Review and Refinement of ATC 3-06 Tentative Seismic Provisions

Report of Technical Committee 5: Masonry

October 1980

REPORT OF TECHNICAL COMMITTEE 5: MASONRY

FIGURE 3

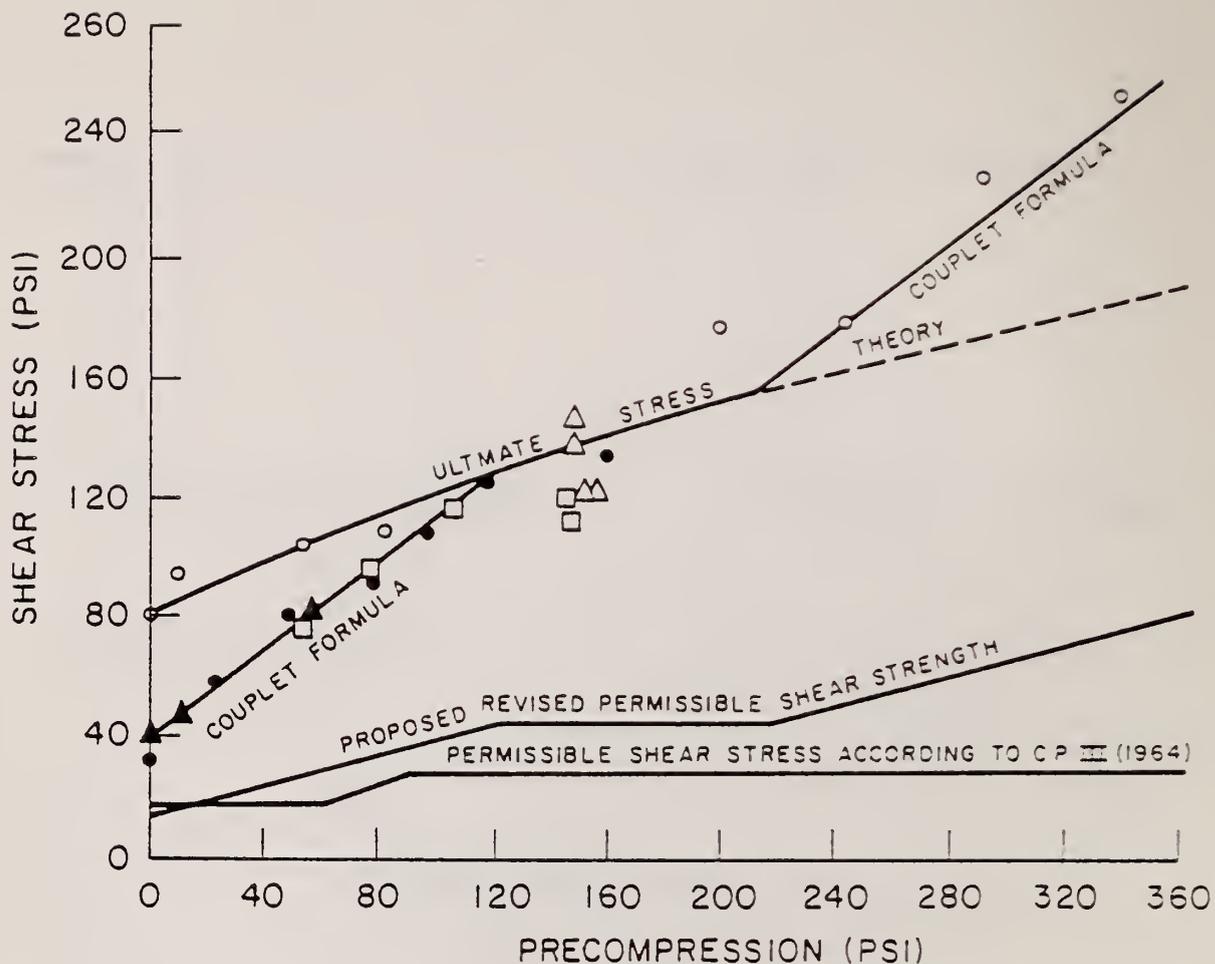
Before pursuing this further the validity of the results of the diagonal compression test shown in Figure 3 will be examined by comparing them with the results obtained from the Berkeley pier test program. At the last meeting Mr. Monk questioned the validity of performing this comparison because of the different stress states in the two test specimen. He correctly stated that regions 1 and 3 will have higher principal tensile stresses due to the combined affects of shear and bending tensile stresses

obtained from the diagonal compression test (Figure 3) is used as the basis for determining code allowables by applying a factor of safety to the test results. This in my view is an incorrect application of the test results. If this is pursued we should compare the shear stresses obtained from *the Berkeley* diagonal compression test and those obtained from the pier tests assuming there is no vertical load. These two values are obtained from the following two equations. For piers

The correct application, in my view is to work with the critical tensile stresses. Since this is not done in practical design its effect should be approximated in the application of the diagonal compression test results. The shear stresses obtained from the diagonal compression test should first be divided by 1.5 to account for the parabolic distribution of shear stress in a structural element. Some factor should then be applied to account for the variation obtained between the diagonal tension stresses of the piers σ_{tcr} and those of the panels σ_{tcr}^2 . From Figures 5 to 7 this would be somewhere between 0.5 and 0.7 say 0.6. Thus the shear stresses obtained from the diagonal compression test should be multiplied by $0.6/1.5=0.4$ before a factor of safety is applied. The factor of safety would then be applied to these reduced values to obtain an allowable shear stress that would be applicable to unreinforced masonry with no compressive load. If this methodology is applied to the results presented in the NCMA commentary where the average shear stress from the panel tests is given as 130 psi for type M and S mortar, the shear stress at failure with no compressive load would be $130 \times 0.4 = 52$ psi. Applying a factor of safety of 3 to this, the allowable shear stress would be 17 psi.

If this procedure is not followed then the upper limits for shear stress should be determined using the methodology recommended herein assuming there is no vertical load on the element. This would involve multiplying the shear stresses obtained from Figure 3 by 0.4 and then dividing these results by a factor of safety of say 3.
